2nd Review

Jan 2025

EAST TOWN CROSSING FRONTAGE IMPROVEMENTS

PERMIT SUBMITTAL

COVER SHEET

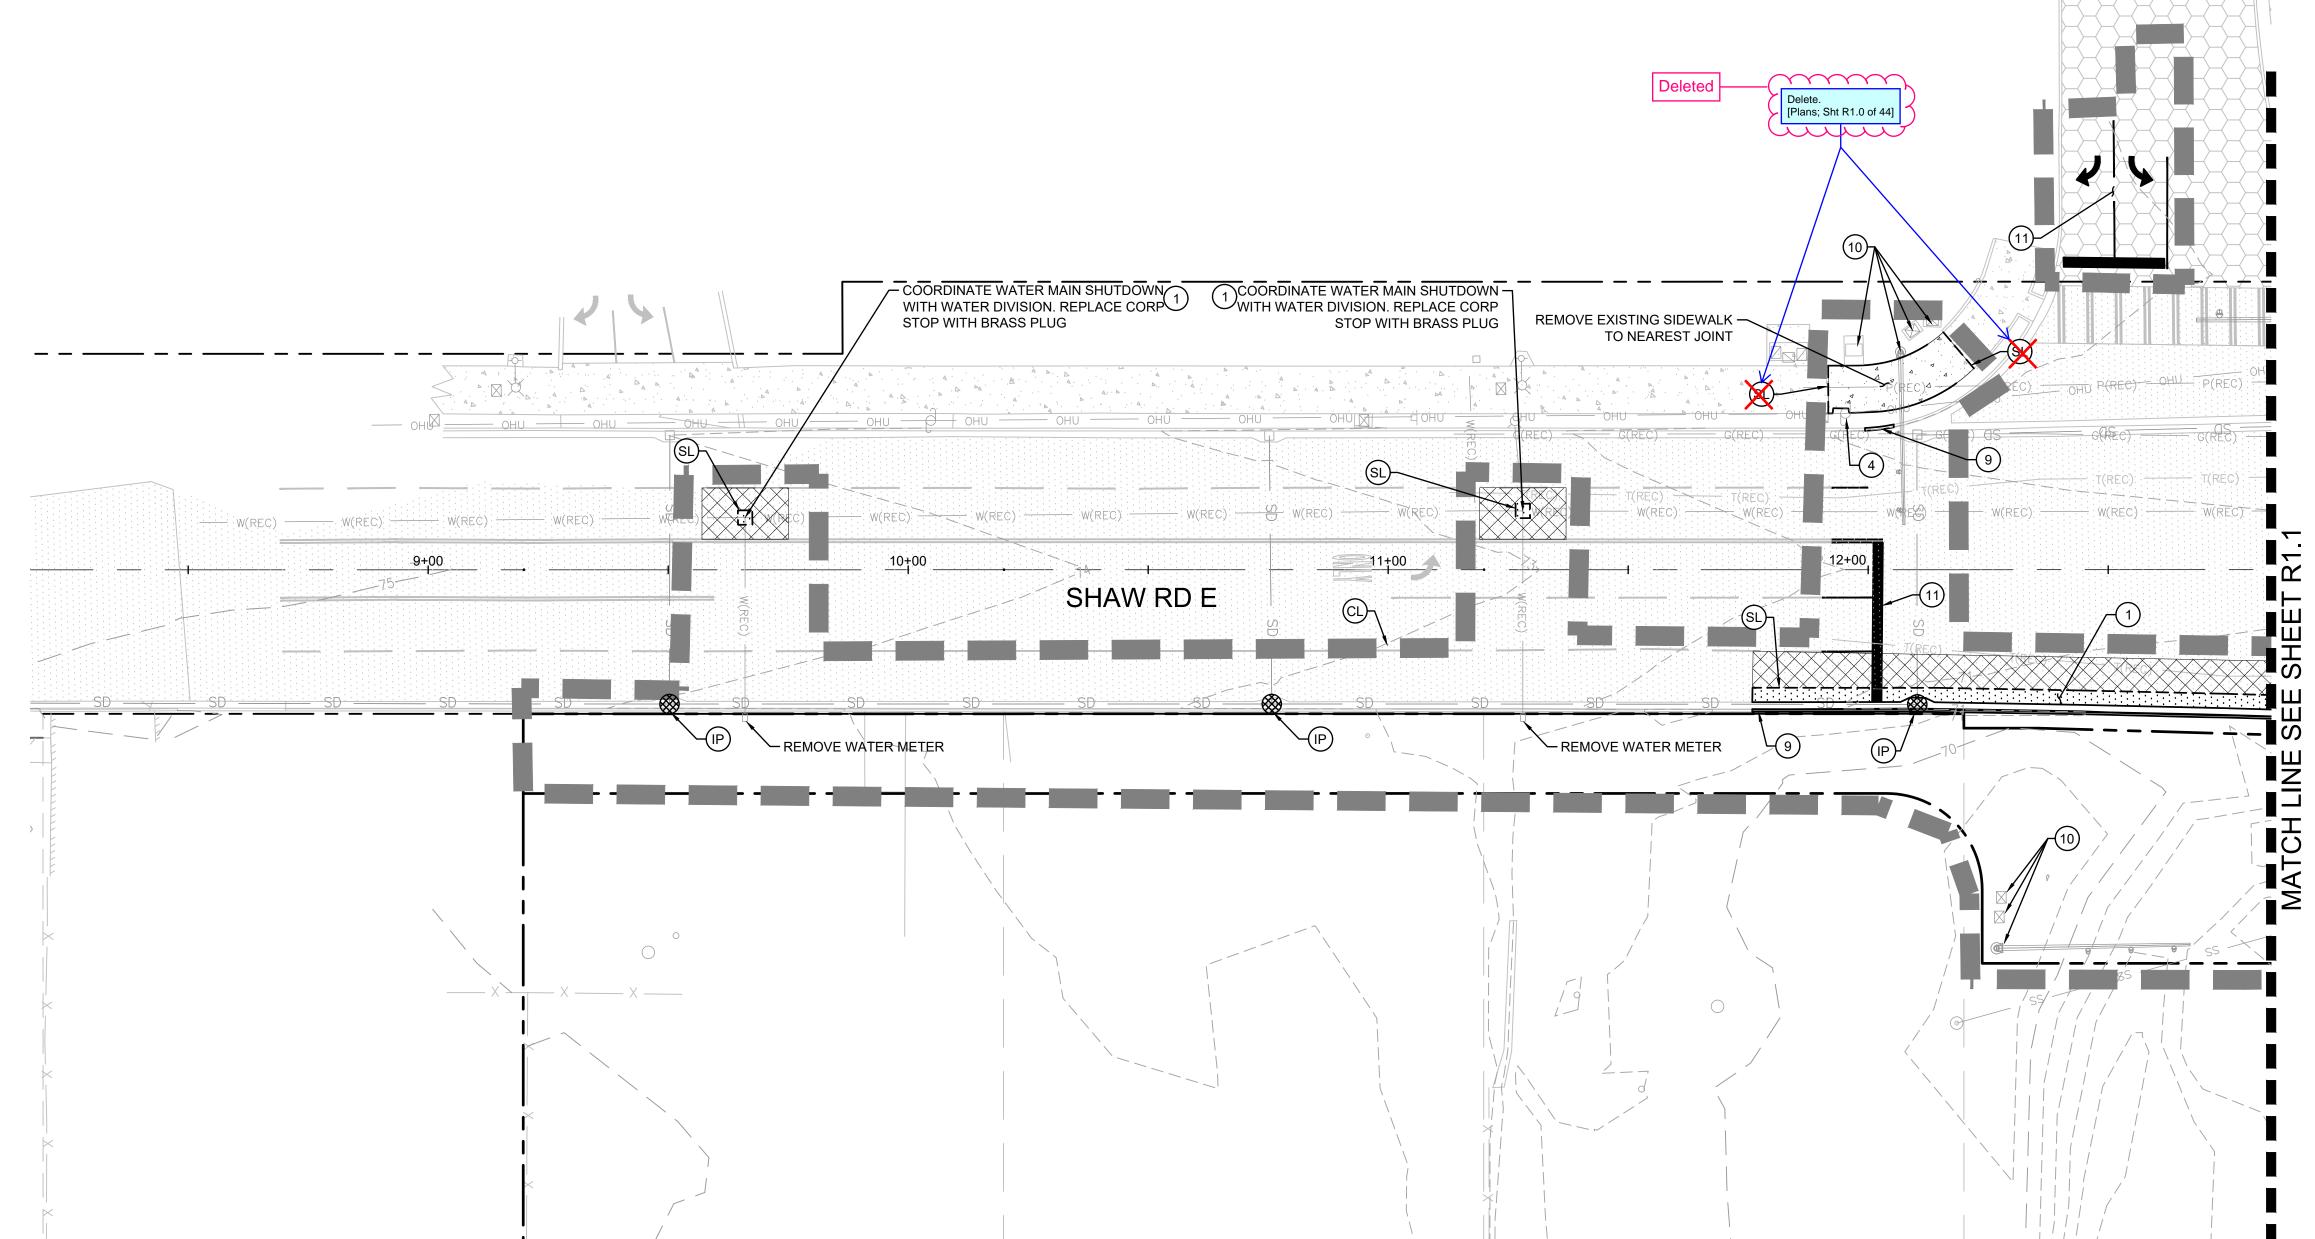
added signage and pavement markings along shaw, as well as provided bus stop, refer to PM plans for additional info on improvements and top left **Sheet List Table**

> Add the following City Standard Notes -General (See CS 2.4) Grading, Erosion, and Sedimentation (See CS 505) -Roadway (See CS 104) Stormwater (See CS 207) [Plans; Sht R0.0 of 44]

Civil Plans - R3.2

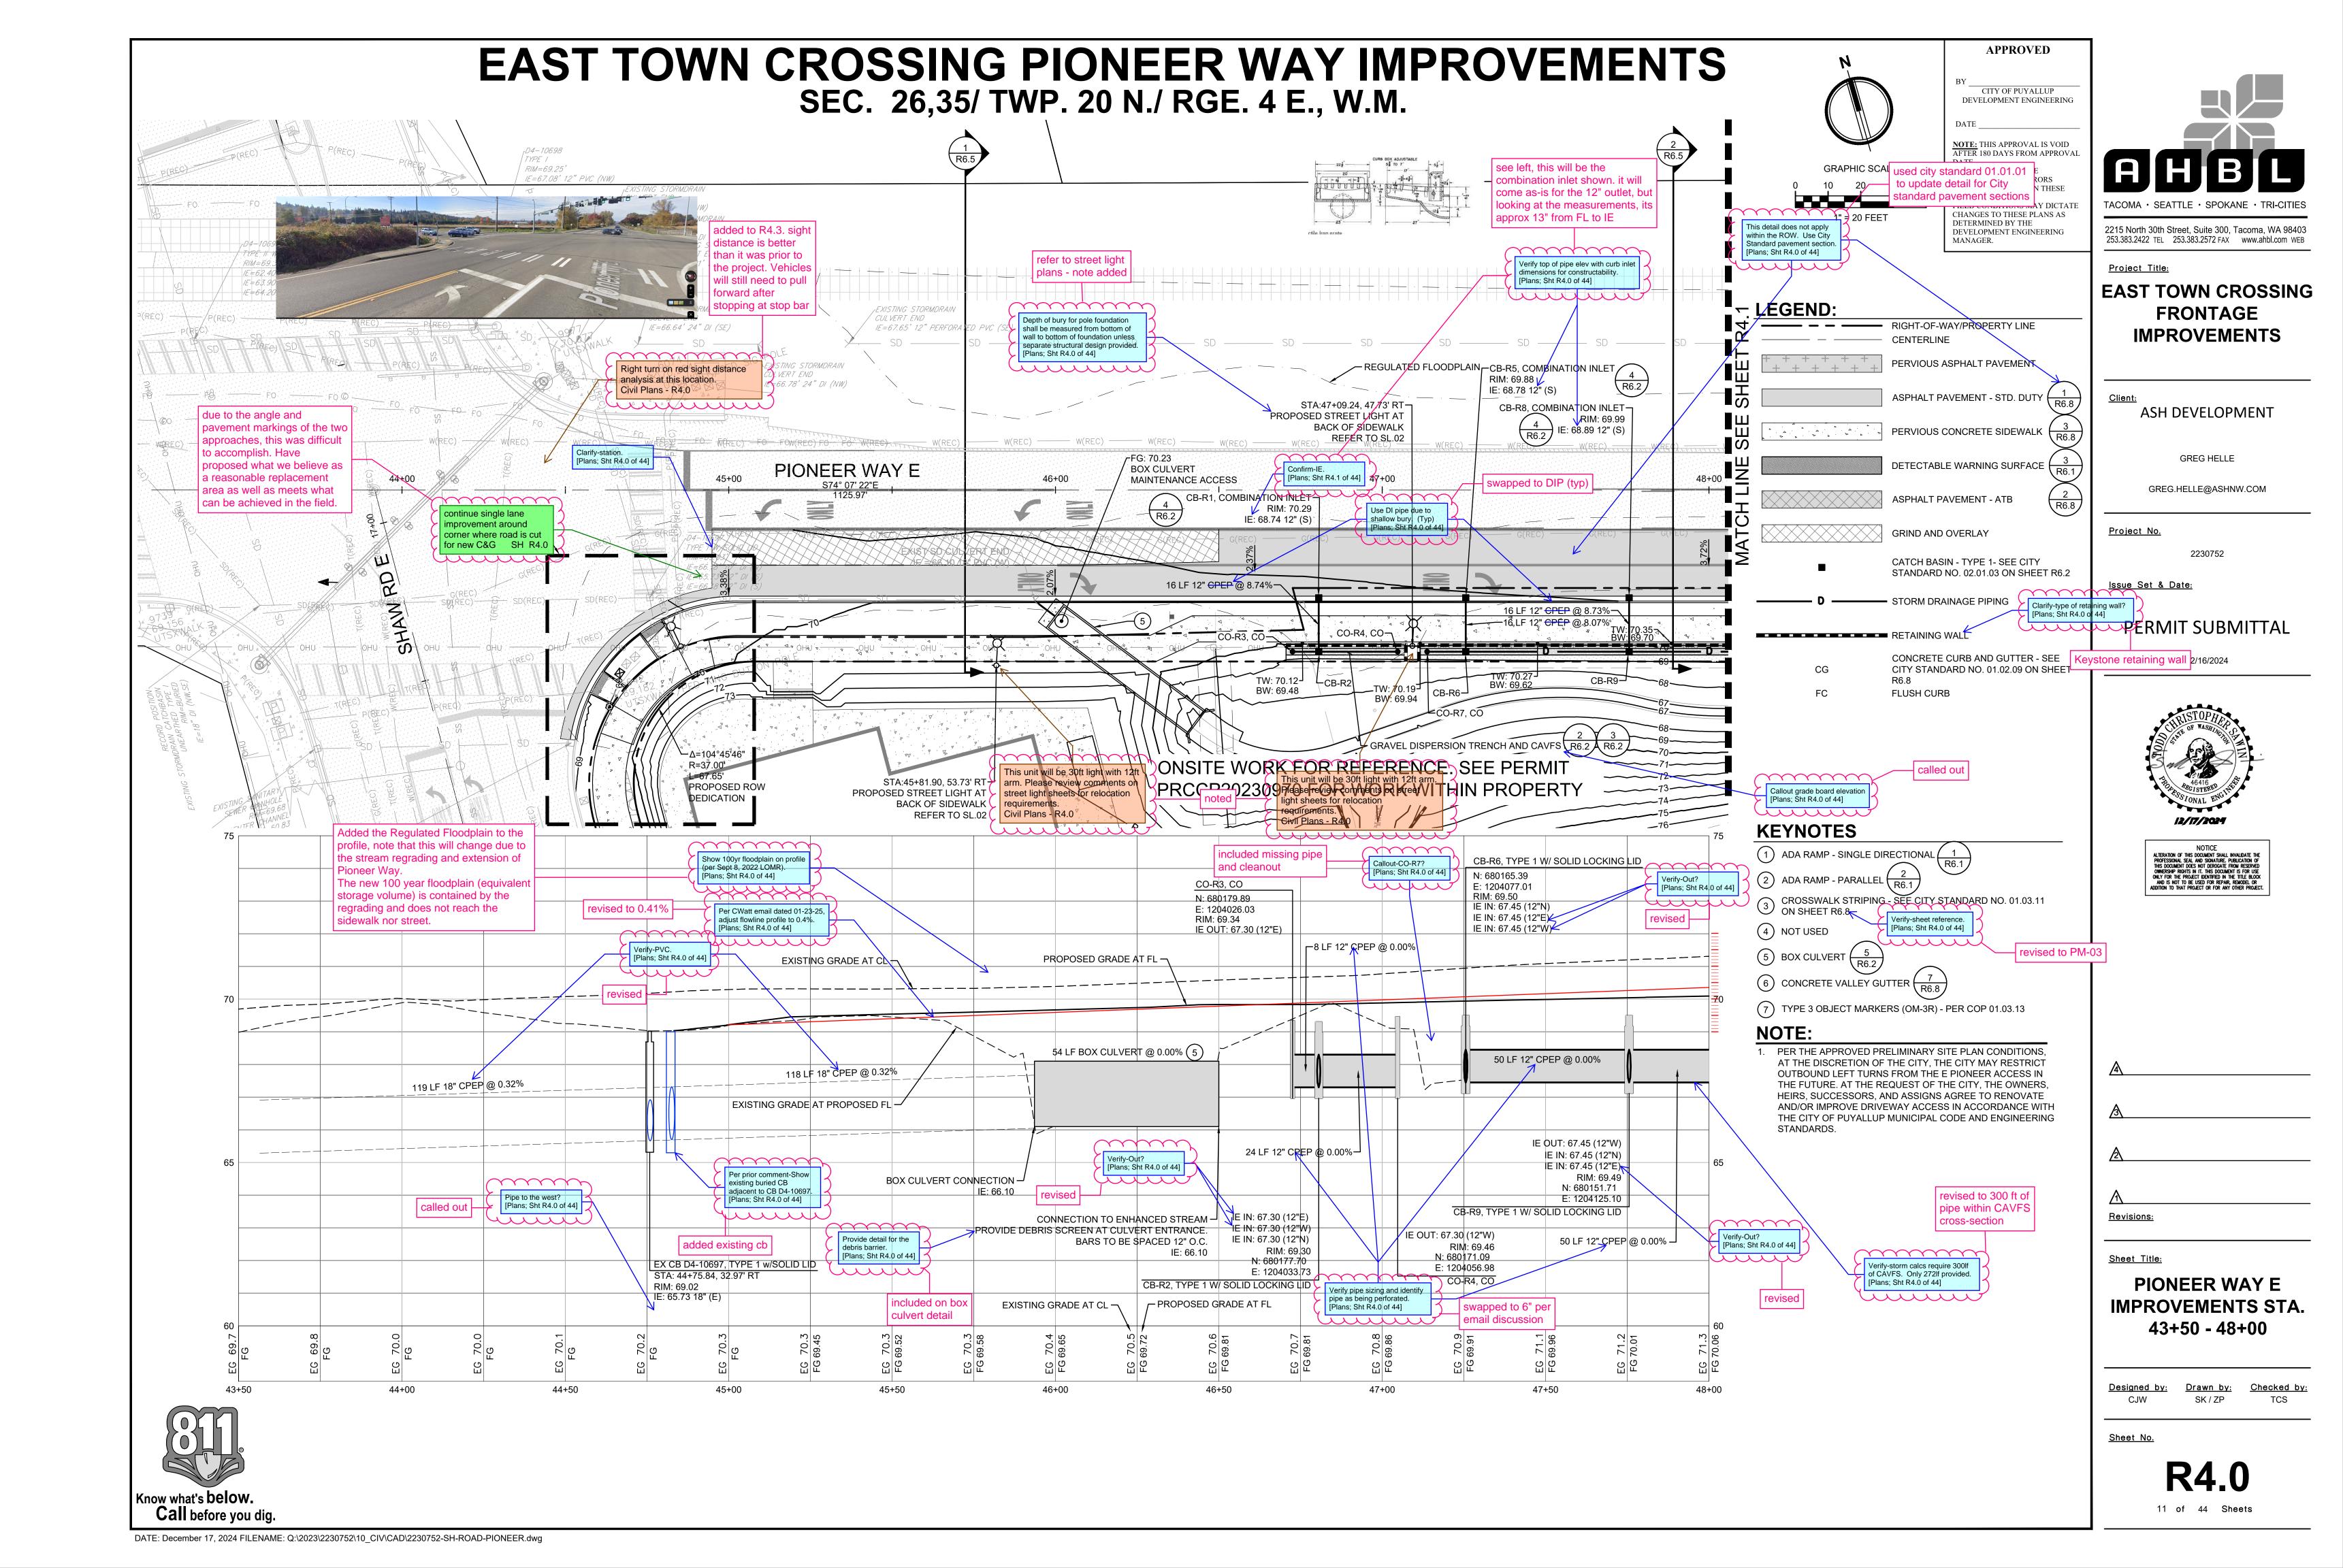
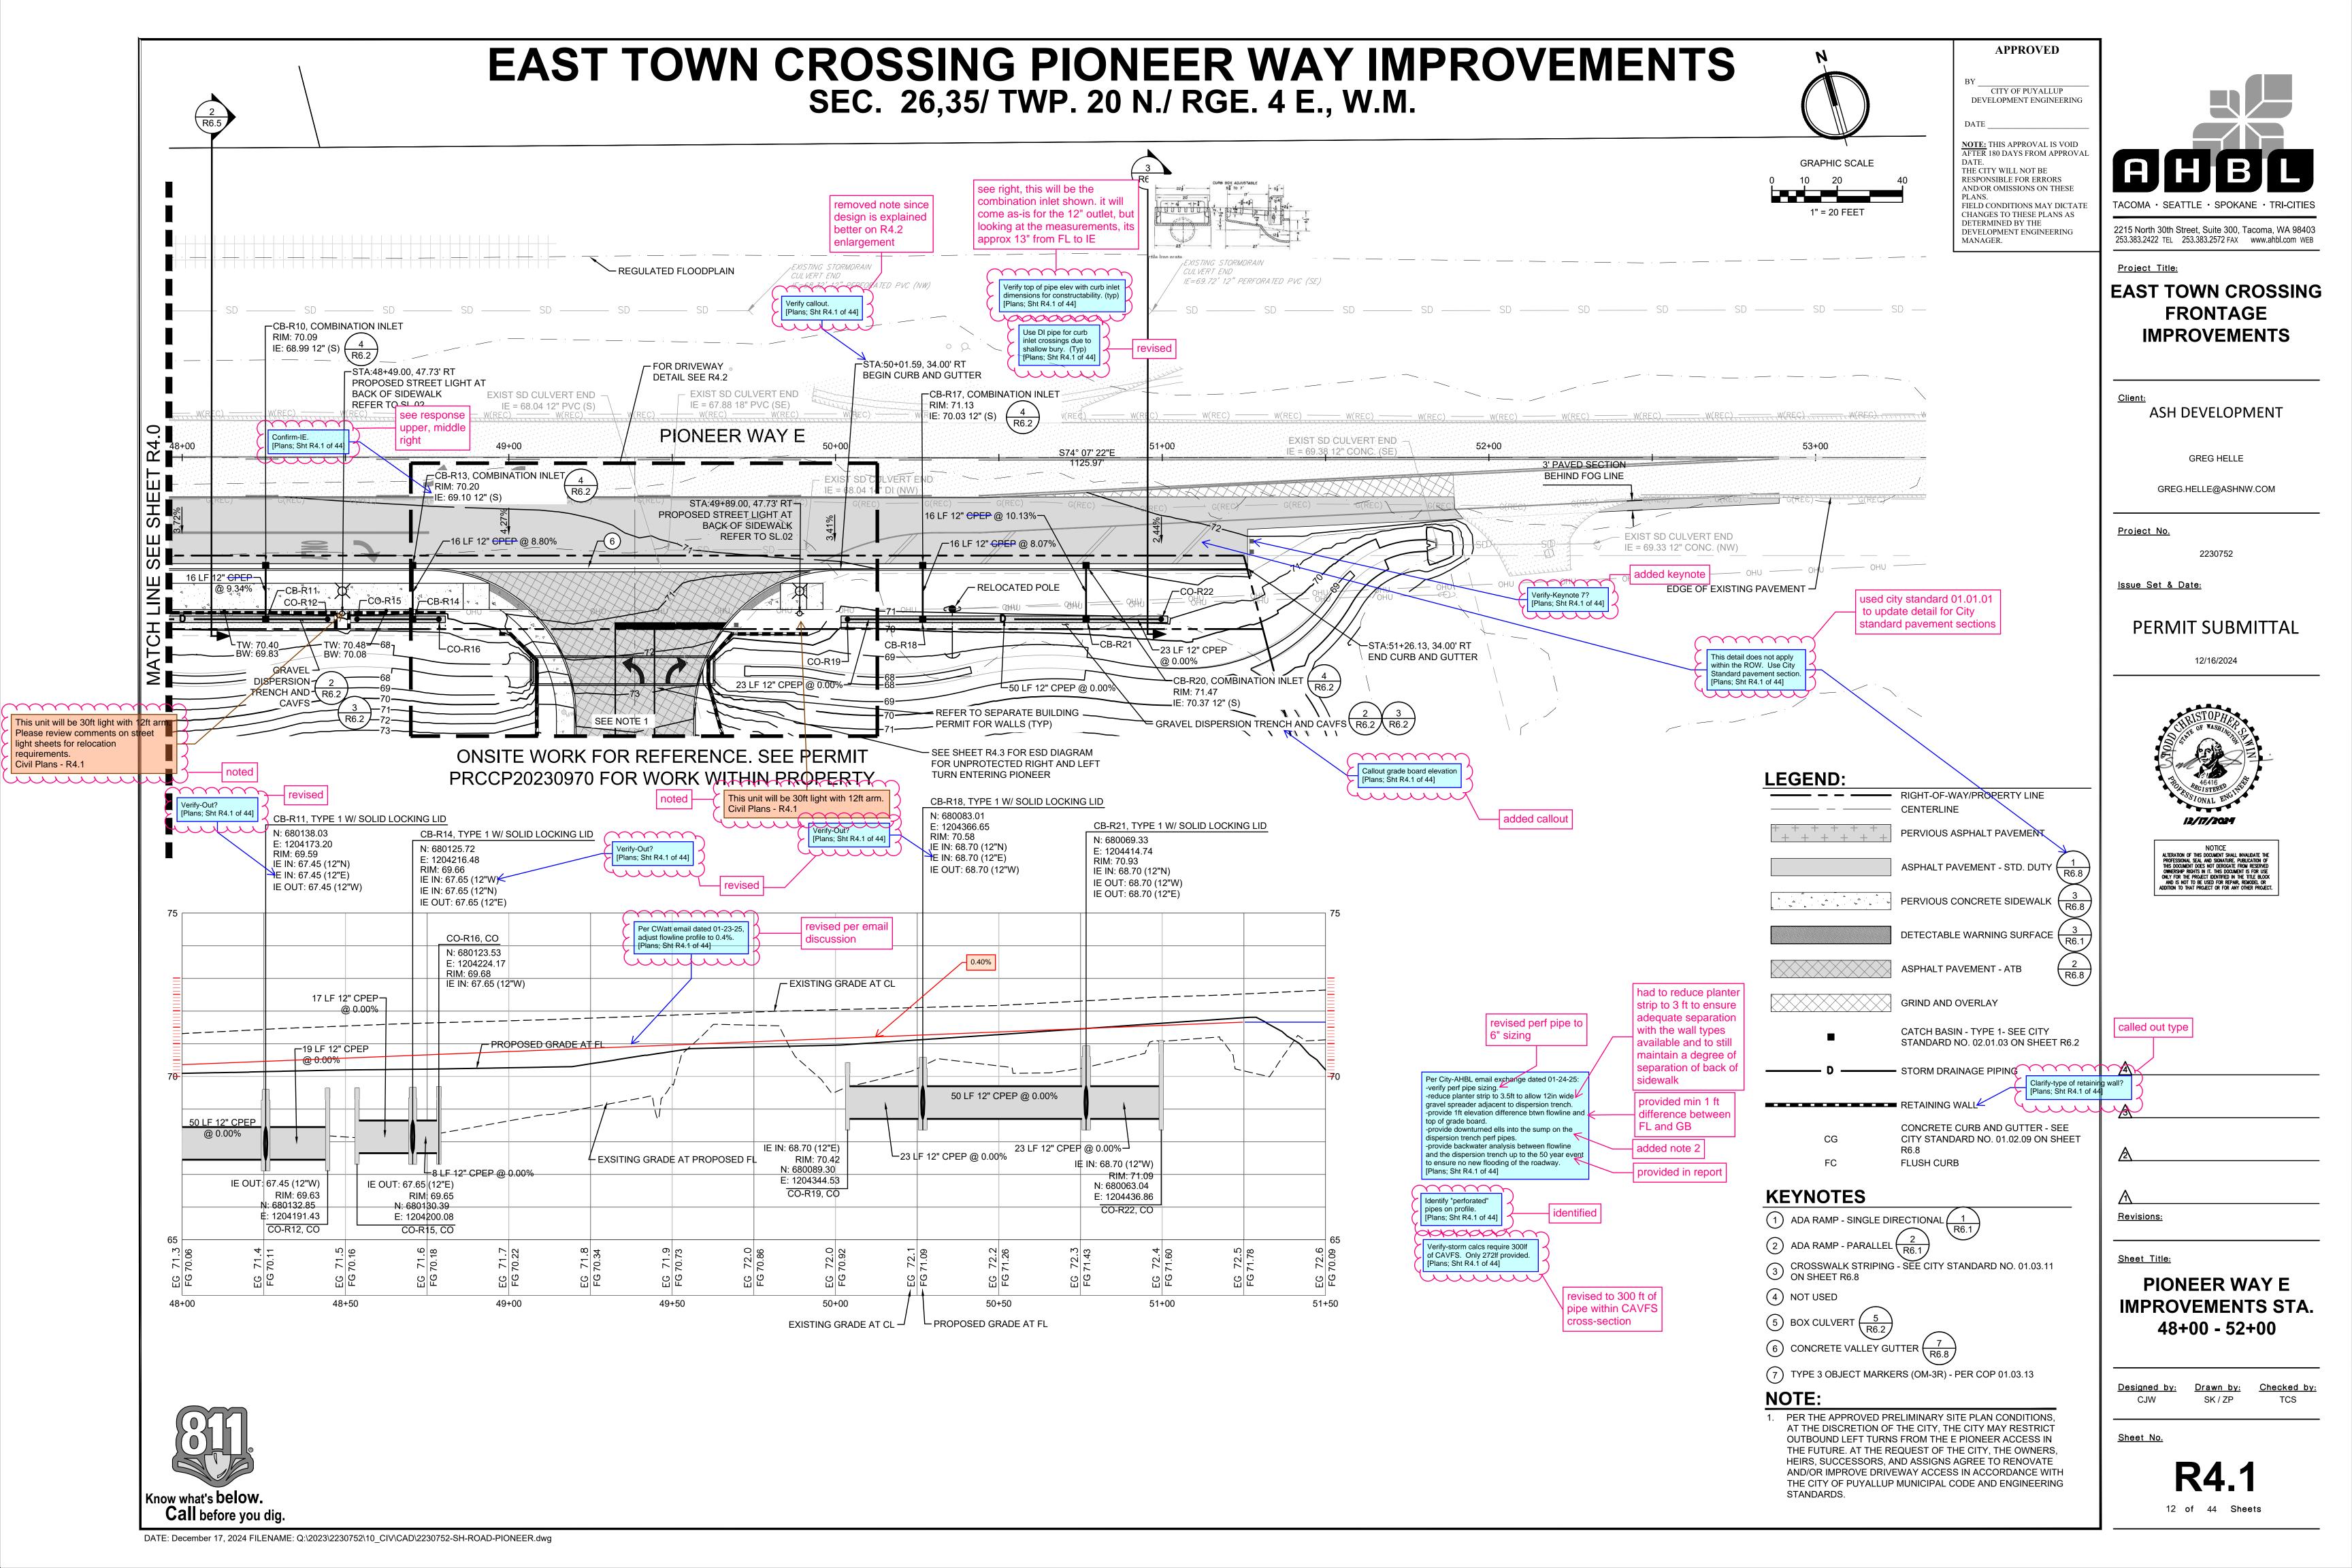
Sheet missing from match
